GFA AD 535
(ISSUE 2)

GFA AIRWORTHINESS DIRECTIVE

**Airworthiness
Directive
2000-074**

SUBJECT: Engine mounting structure (pylon)

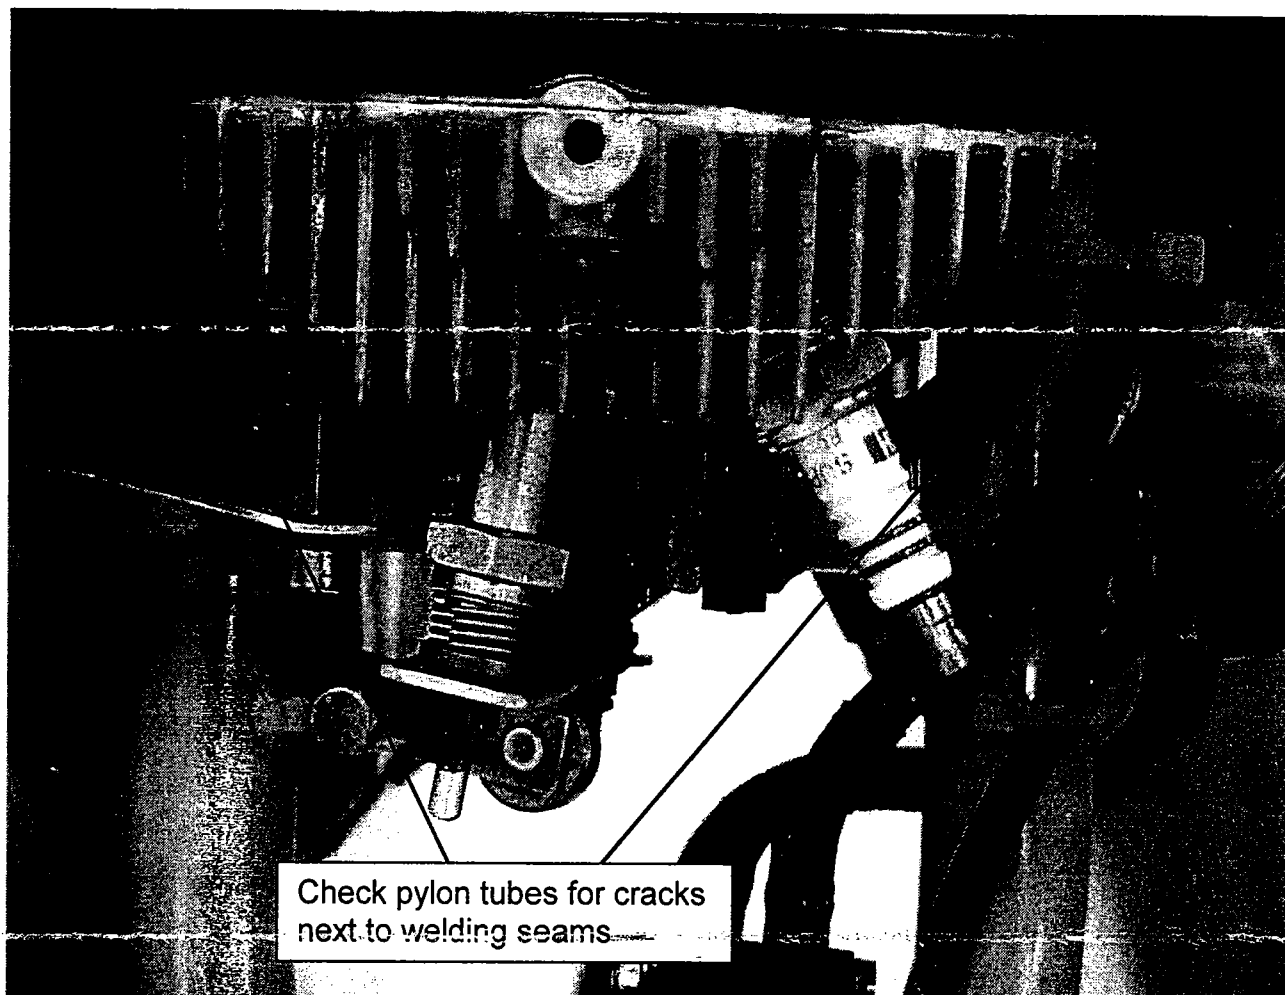
Check pylon tubes at the welding seams of the lower engine mount for cracks
- see also photographs enclosed.
If damage (cracking) is found, the pylon must be removed and returned to the manufacturer.
